Product Change Notice (PCN)

Subject: Addition of production sites and material changes for RH850/F1KM-S1 Series

Revision Description: Initial Release (HPLM-2025-0064)

Mark Specification

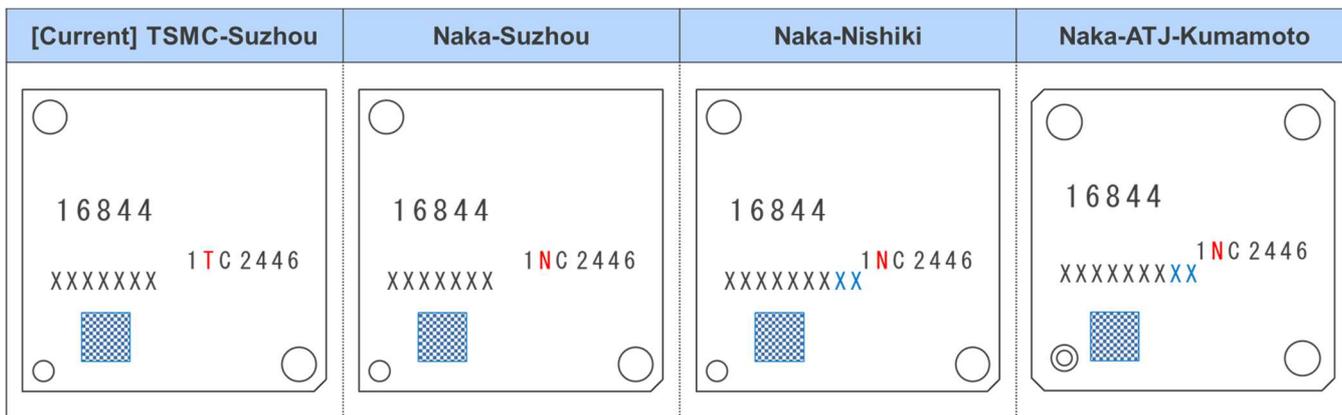
Mark Example: R7F7016844AFP(D)-C#BA1 (F1KM-S1 100pin)

The red character is different between TSMC and Naka products (TSMC: T, Naka: N).

The digit number of Trace Code is different between Suzhou and Nishiki products (Suzhou: 7digits, Nishiki: 9digits).
(The blue characters)

There are differences in the outline of ATJ-Kumamoto products.

Label Specification

The red characters are different between TSMC and Naka products.

The blue characters are different between Nishiki, ATJ-Kumamoto and Tera Probe products.
